APPEAL SUMMARY

Appeal ID: 23492	Project Address: 1336 N Watts St
Hearing Date: 2/26/20	Appellant Name: William Neburka
Case No.: B-006	Appellant Phone: 5035452506
Appeal Type: Building	Plans Examiner/Inspector: Anne Schmidt
Project Type: commercial	Stories: 3 Occupancy: R-2 Construction Type: V-B
Building/Business Name:	Fire Sprinklers: Yes - All
Appeal Involves: Erection of a new structure	LUR or Permit Application No.: 19-190314-CO
Plan Submitted Option: pdf [File 1]	Proposed use: Residential

APPEAL INFORMATION SHEET

Drawing Title:
Building Elevations

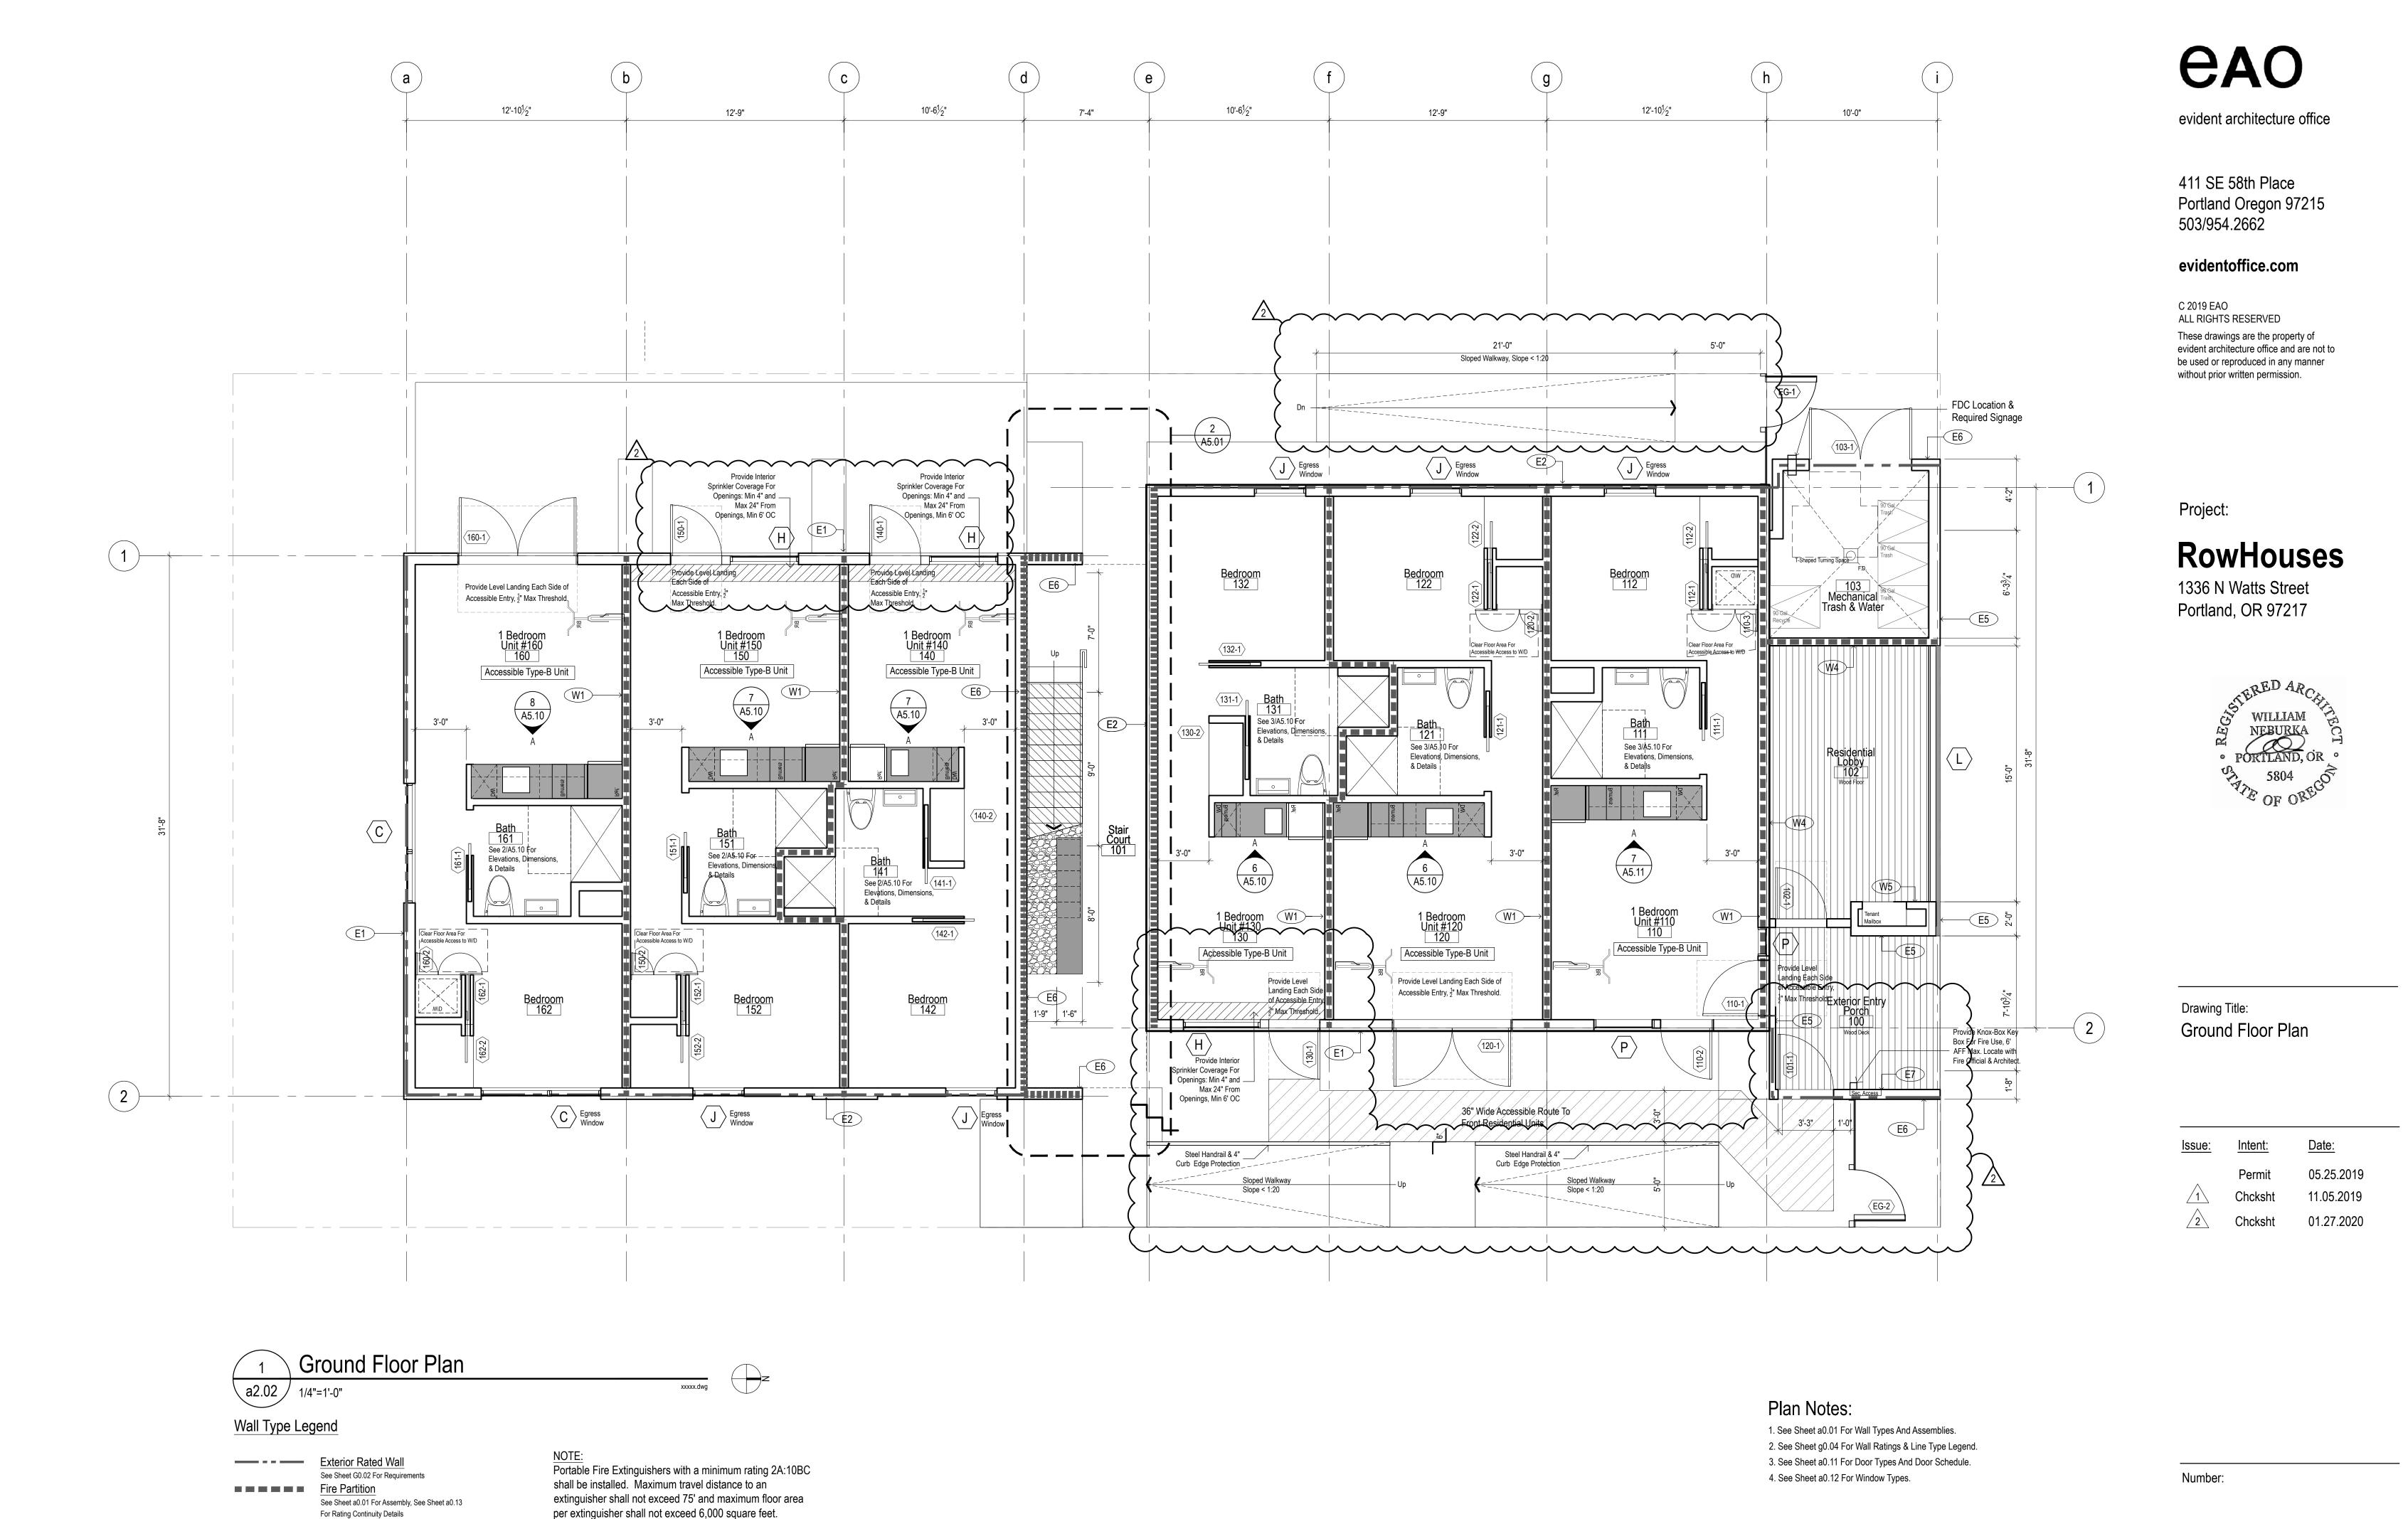
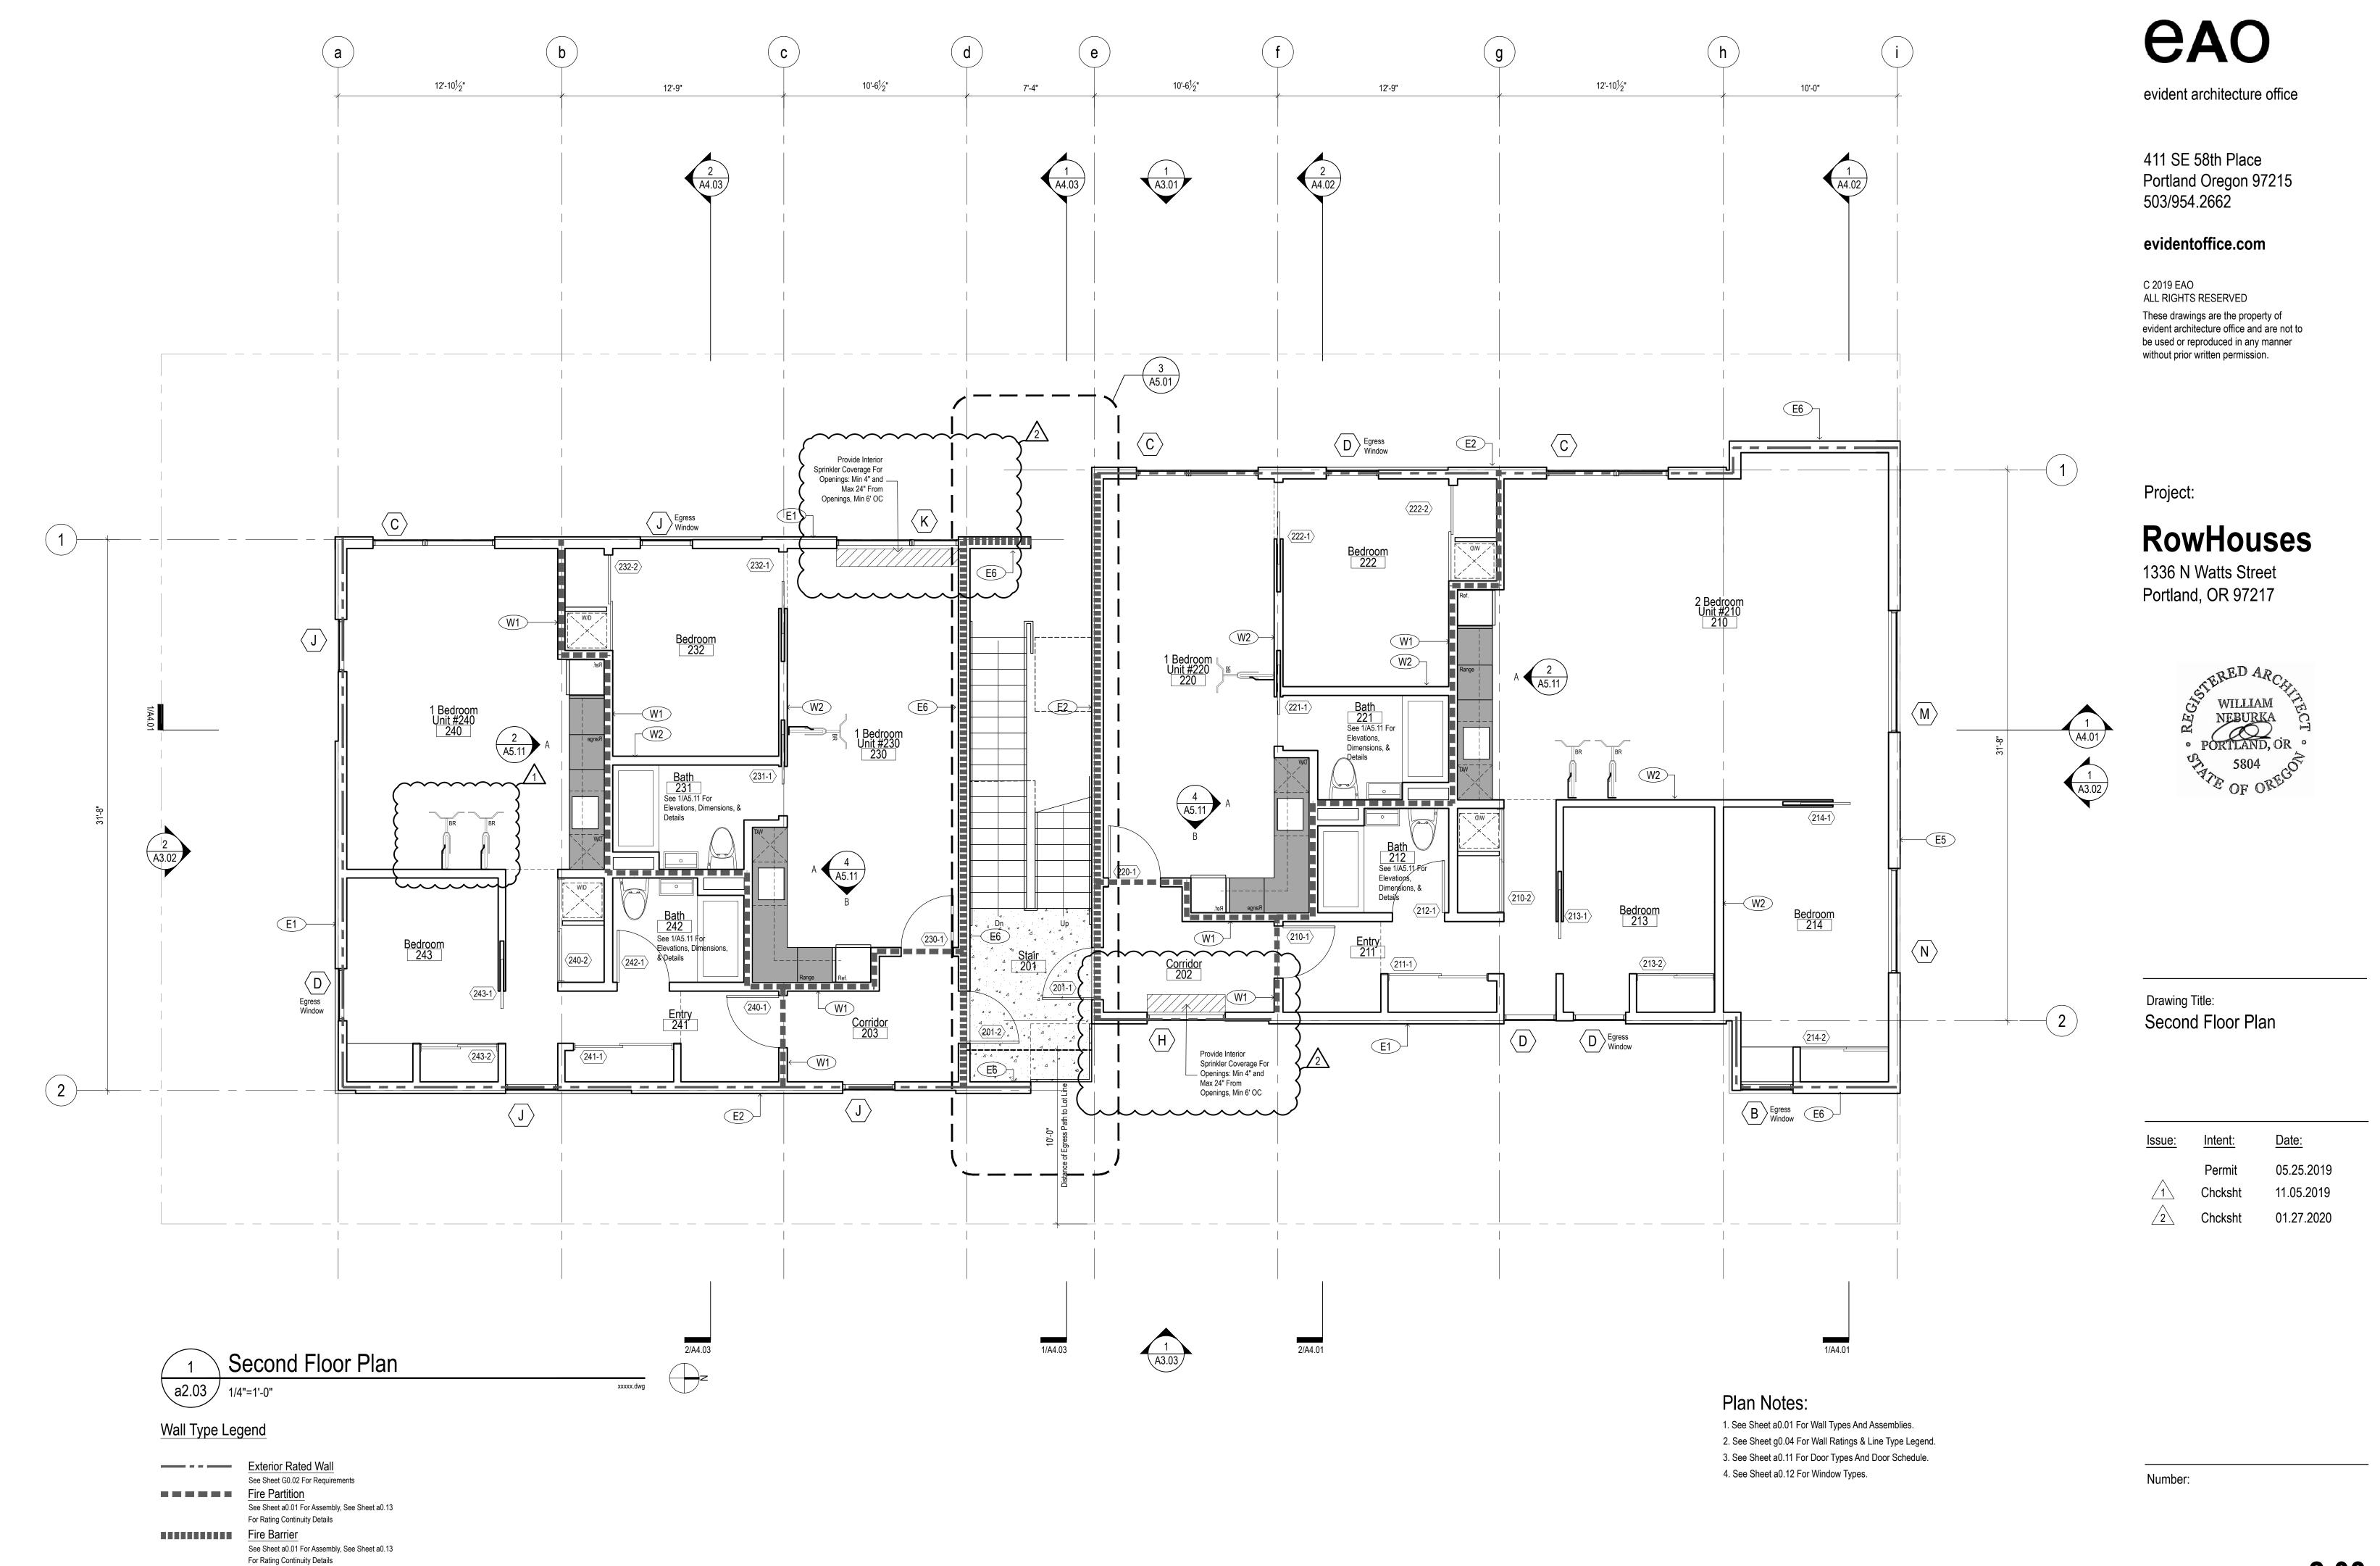
Our project contains a single exterior stairway serving 4 units on 2 floors. The stairway is separated from the occupied space by the required 1hr assembly. At the northeast corner of the stair the exterior wall returns north along the face of the building. We have indicated that the rating extend for 10' northward which contains windows and doors providing light and access to the adjacent tenant spaces. We propose providing fixed window units with tempered glass in these locations and provide a sprinkler head providing coverage at each opening, spaced a minimum of 4" and a maximum of 24" from the glass plane. The city has granted this type of appeal previously on numerous projects.

At the ground floor a single unit entry/egress door falls within the 10' extension of the rated wall. We propose a solid wood frame, single lite entry door with a tempered glass lite and spring-loaded self-closing device.

Where we do not need operable windows for required ventilation or egress, we propose providing conventional fixed window units with tempered glass in these locations, and providing sprinkler head coverage at each opening, spaced a minimum of 4" and a maximum of 24" from the glass plane. The city has granted this type of appeal previously on numerous projects.

Where unit entry/egress doors fall within this adjacency requiring protection, we propose We propose solid wood frame, single lite entry doors with a tempered glass lite and spring-loaded selfclosing device.

1. Type 13 water curtain sprinkler protection at non-fire rated openings in exterior walls within 180 degrees of exit stair: Granted provided windows are non-operable and sprinklers are spaced not more than 6 feet apart and placed a minimum of 6 inches and a maximum of 12 inches from the opening(s) and a maximum of 12 inches below the ceiling. Sprinklers are to be installed on the occupied side of the openings. A separate permit from the Fire Marshal's Office is required.

- 2. Type 13 water curtain sprinkler protection at non-fire rated openings in buildings with vertical exposure on separate lots: Granted provided;
- a. Windows are non-operable and sprinklers are spaced not more than 6 feet apart and placed a minimum of 6 inches and a maximum of 12 inches from the opening(s) and a maximum of 12 inches below the ceiling. Sprinklers are to be installed on the occupied side of the openings. A separate permit from the Fire Marshal's Office is required.
